Re: Initial Submission Review – Highline Village Subdivision Filing No 3 – Plat Amendment
Application Number: **DA-2228-00**
Case Number: **2020-3013-00**

Initial Submission Review

HIGHLINE VILLAGE

INITIATING TR PLA

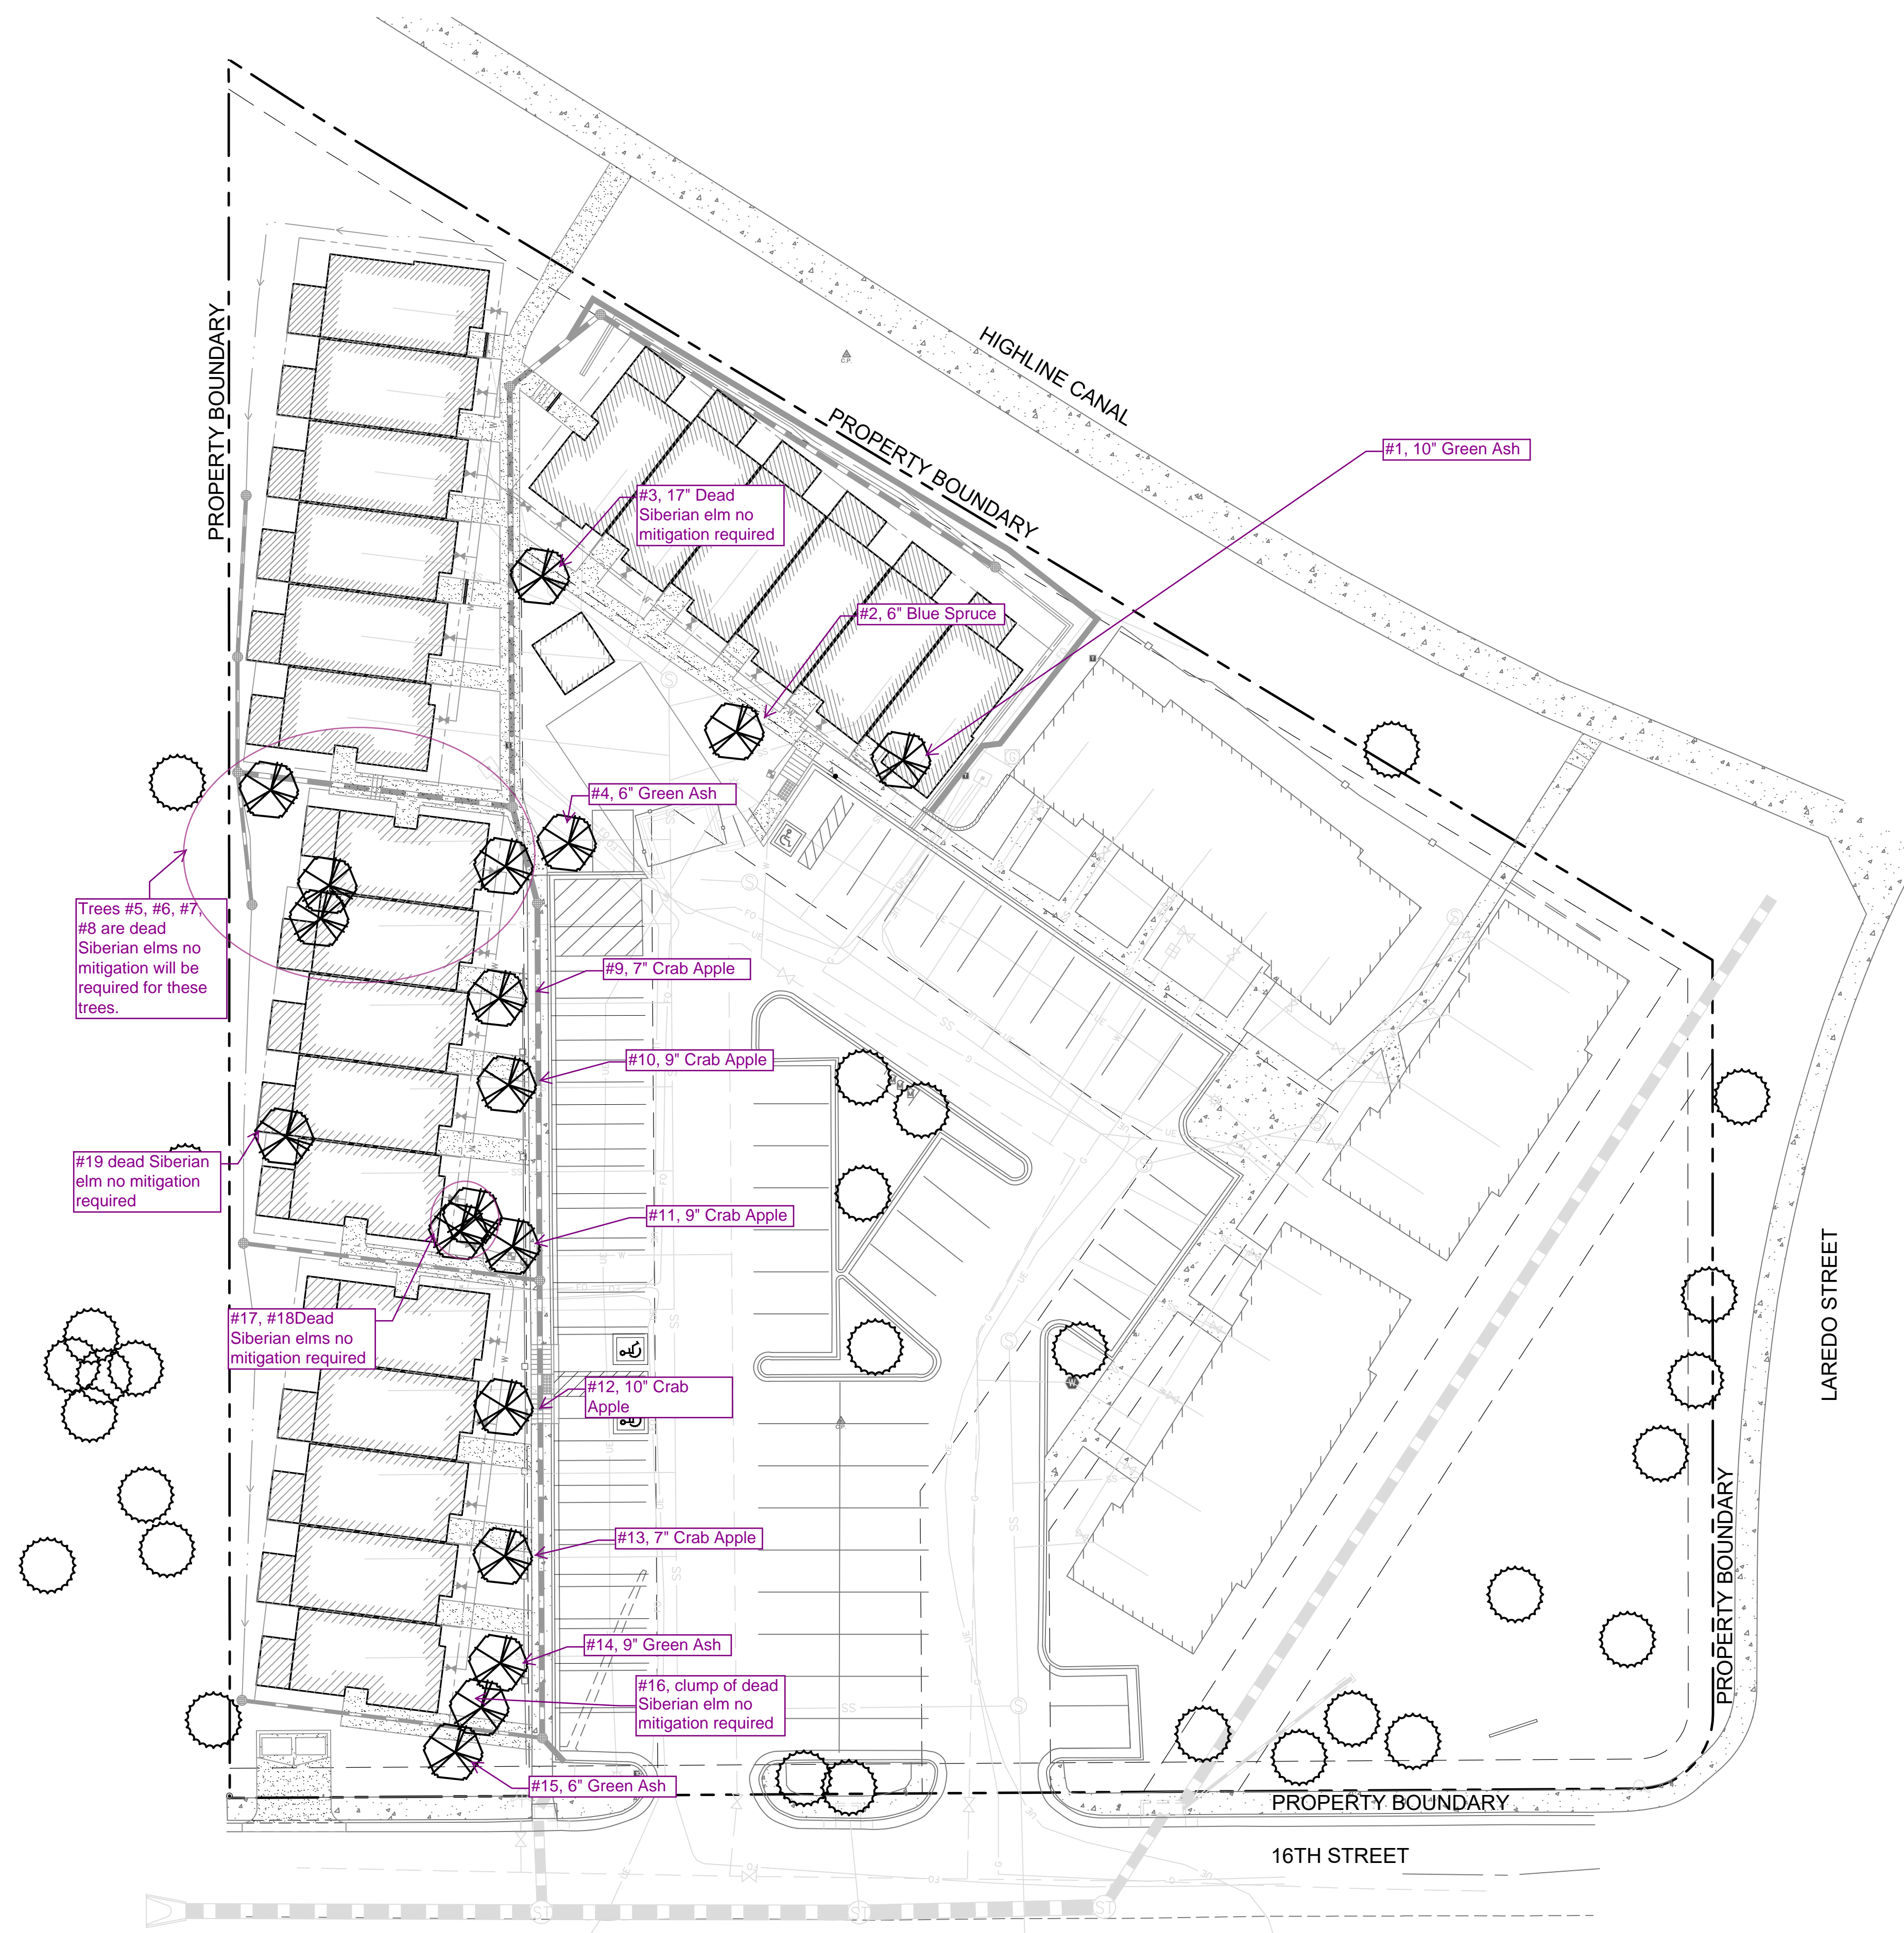
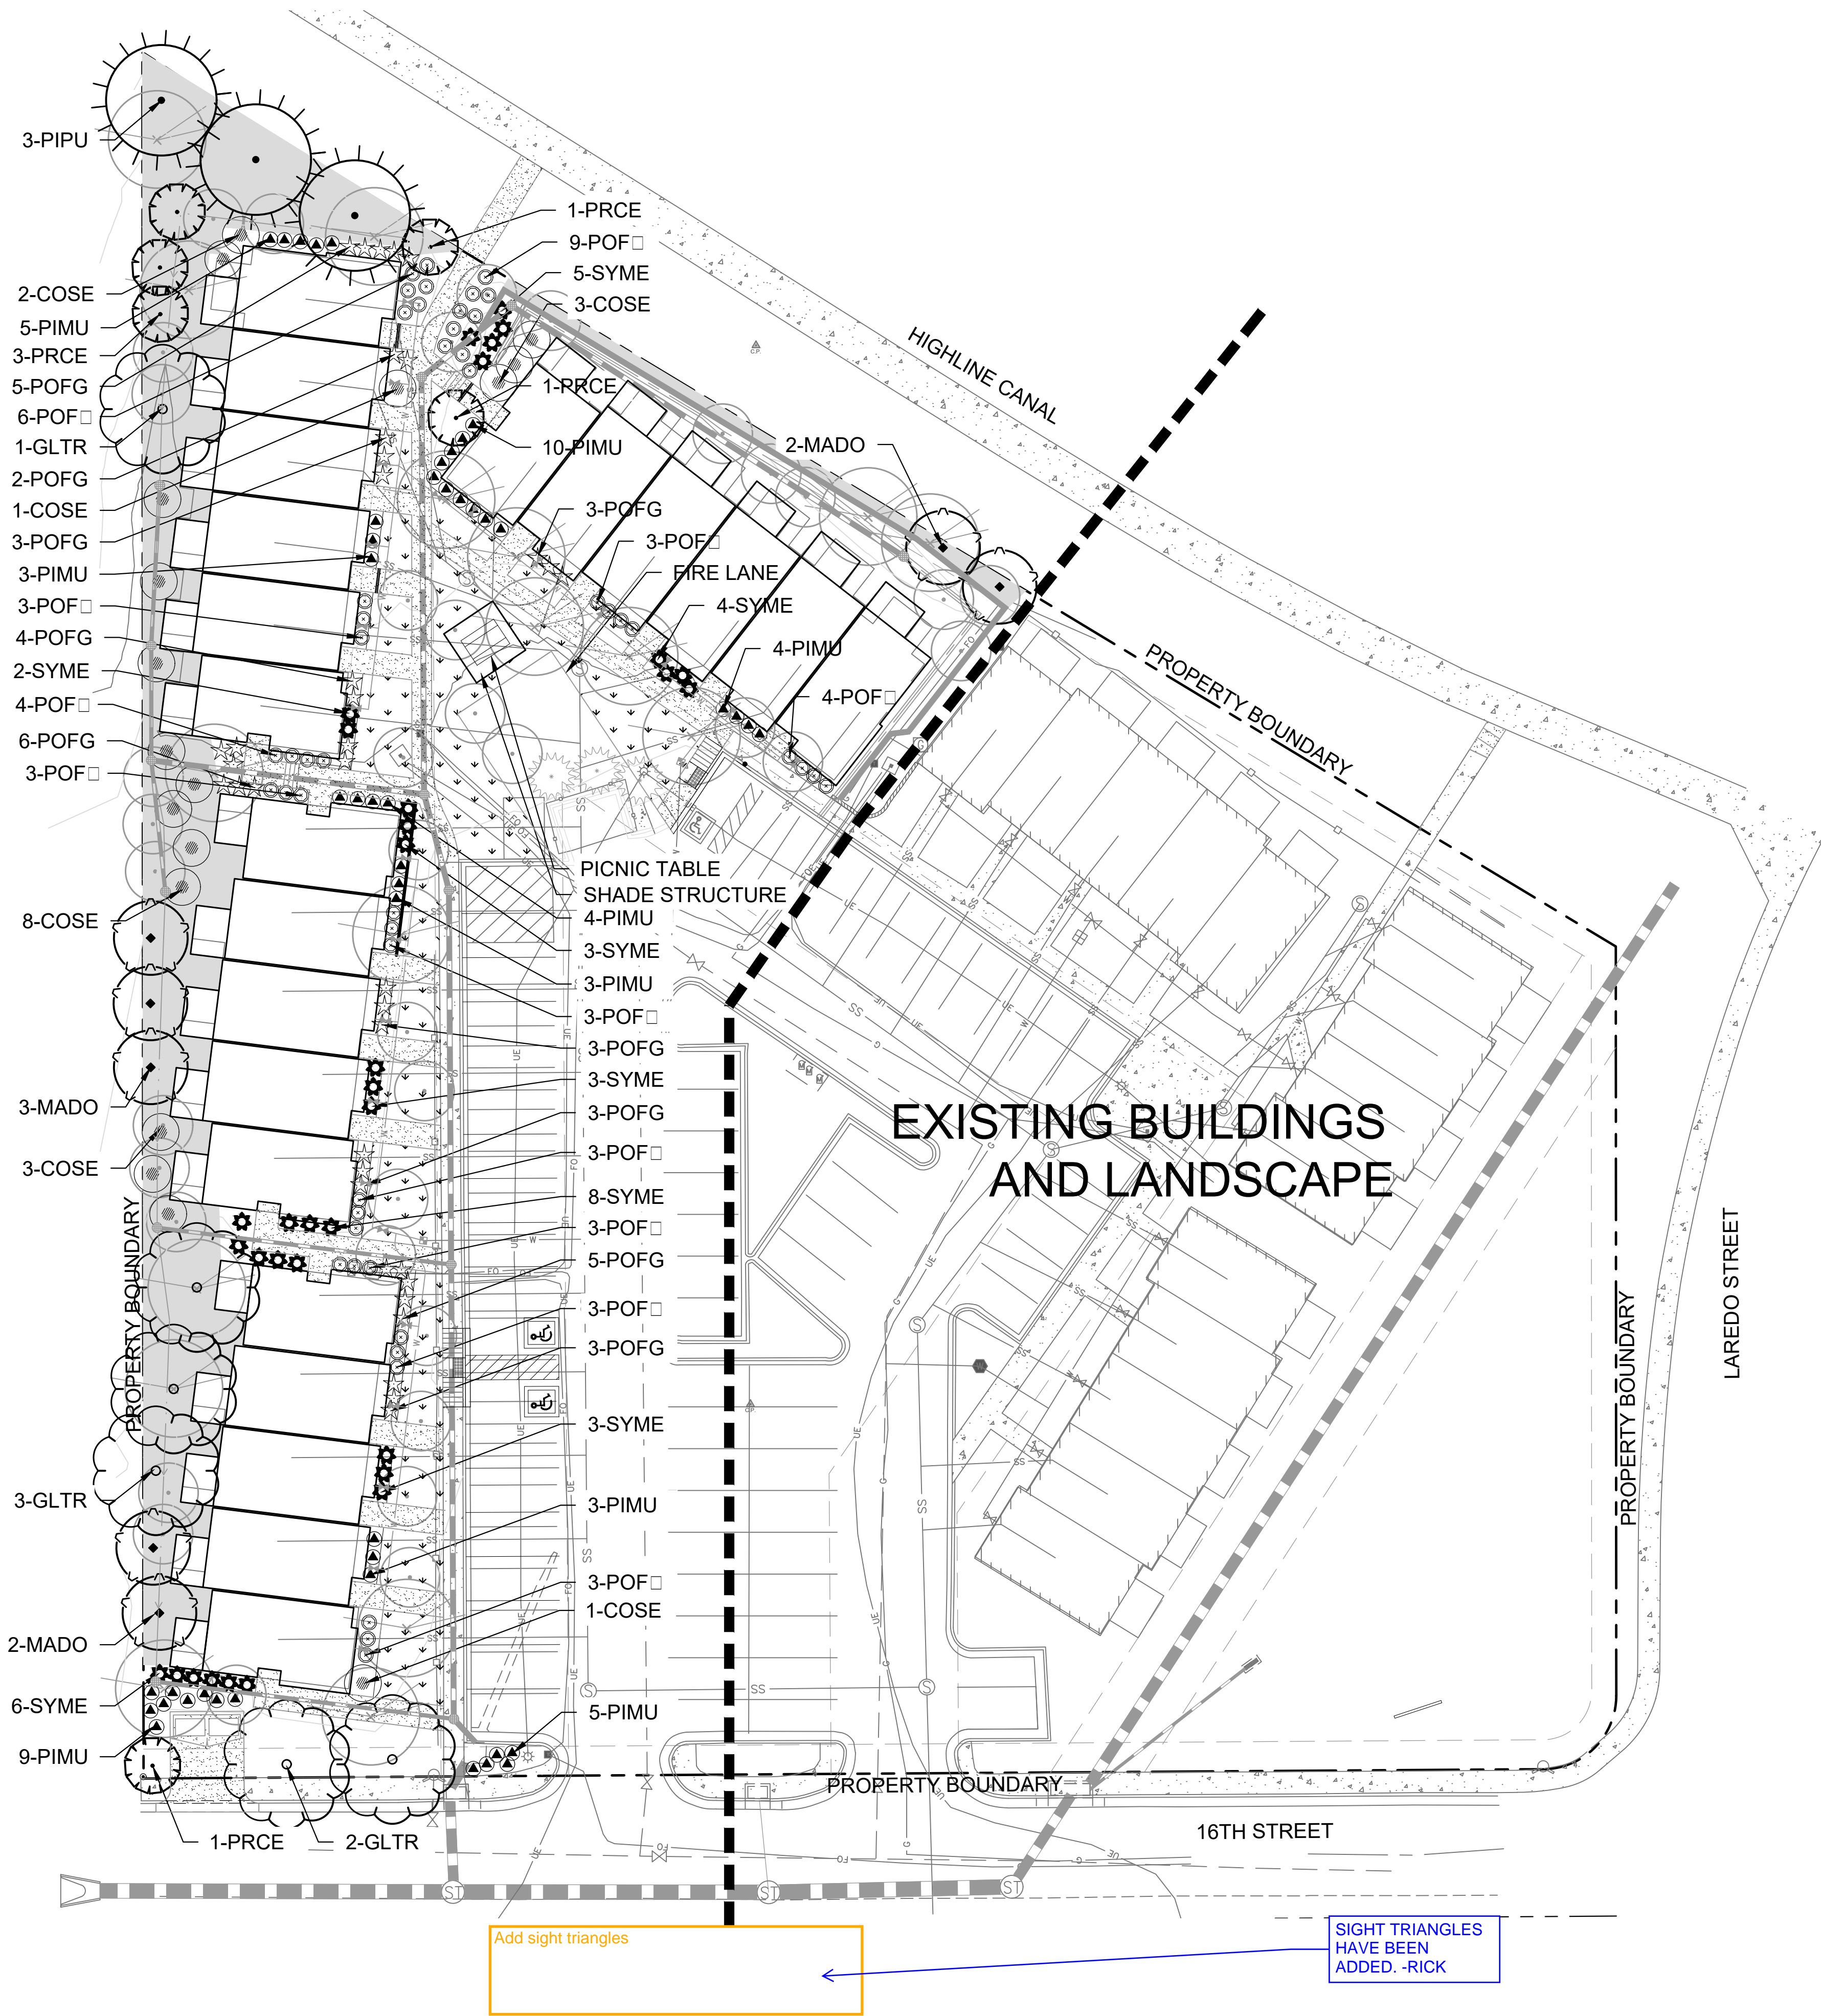
Any trees that are preserved on the site during construction activities shall follow the standard details for Tree Protection per the current Parks, Recreation & Open Space Dedication and Development Criteria manual. Parks, Recreation & Open Space Dedication and Development Criteria manual. These notes shall be added to the plan.

Please show a tree mitigation chart on the landscape plan taken from the Landscape Manual page 29. If payment will be made into the Tree Planting Fund, add another column to the chart indicating the payment amount that will be made. If trees will be planted on the site, please show a symbol indicating trees that are specific to tree mitigation.

NOTES HAVE BEEN
ADDED. -RICK

TREE MITIGATION
CHART HAS BEEN
ADDED. -RICK
